Caerphilly County Borough Local Development Plan

Joint Statement of Common Ground Between Caerphilly County Borough Council and Environment Agency Wales HG1.25 - Navigation Colliery

ED.22

HG1.25 - Navigation Colliery

EAW Model 0.1% Flood Outline

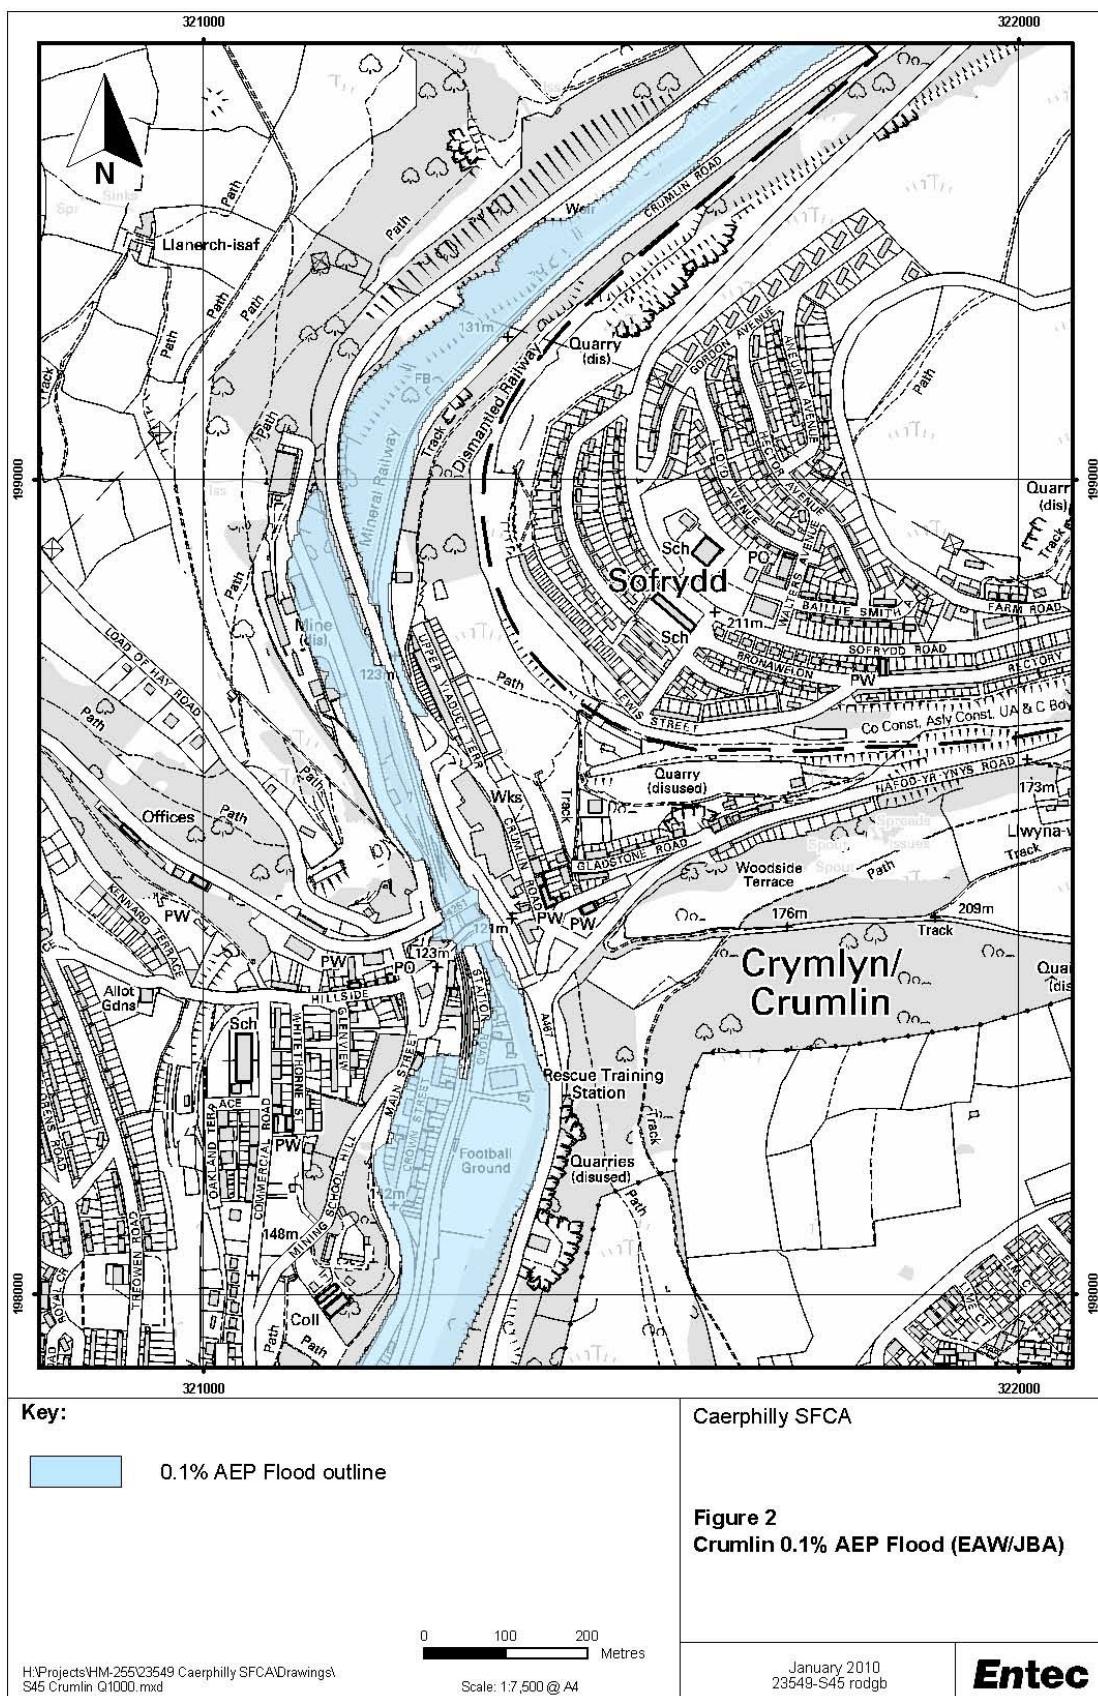
- S6 EAW presented output from their model that had been completed in August 2009. The flood outline for the 0.1% extreme flood from the EAW Model appeared similar to the outline shown by the CCBC Model (EAW and Entec Models flood outlines are included as Appendices 2 and 3 respectively). The site is long and narrow and is constrained by steeply rising land along the western part, which incorporates a rise of 12.5 metres at the western extent of the 0.1% extreme flood outline. Given this change in levels, Entec anticipated that flood levels would have to rise by approximately 15 metres before significant expansion of the flood extent occurred.

- S14 It was agreed that if the site allocation was constrained to prevent development in the 0.1% extreme flood outline, the downstream impacts and necessary mitigation could be properly assessed at a detailed planning stage. It was agreed that the most conservative 0.1% extreme flood outline is used to inform this to compensate for the differences between both models.

- S15 Following the meeting, Entec did some work to compare both models. Even though they considered that it was possible that the 1% flood event plus 50% blockage scenario to be more severe than the 0.1% extreme flood event outputs from the CCBC Model, they considered that the flood levels used in the EAW Model to be sufficiently conservative to compensate for this difference. It was concluded that the EAW modelled 0.1% extreme flood outline should be therefore be used.

- 1) It was agreed that the 0.1% extreme flood outline from the EAW Model is used to inform at a strategic level the amount of developable area on site. This outline is included as Appendix 2.
- 2) It was agreed that the detailed assessment of impact on flood risk elsewhere, particularly downstream, would be more appropriately addressed by the proposed developer at the detailed planning stage.
- 3) It was agreed that the site was significantly constrained by flooding and this would restrict the area of development, except where a developer was able to provide
